CERTIFICATE OF APPROPRIATENESS

Property: 1548 Cortlandt Street, Tract 24A, Block 138, Houston Heights Subdivision. The property includes a historic 988 square foot, one-story wood frame single-family residence and a detached garage situated on a 5,000 square foot (50' x 100") corner lot.

Proposal: Alteration/Relocation/Addition –

Recommendation: Denial - does not satisfy criteria: 1, 3, 4, 5, 8, 9, and 10

FIRST FLOOR PLAN

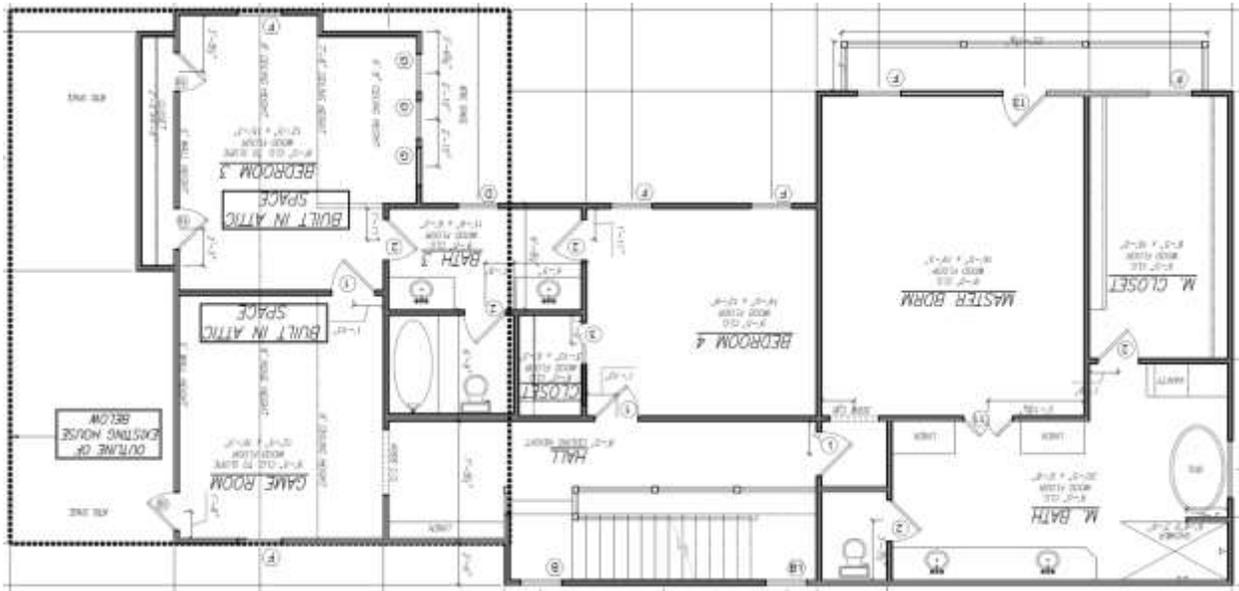
Sanborn maps indicate that this rear bay is original to the house.
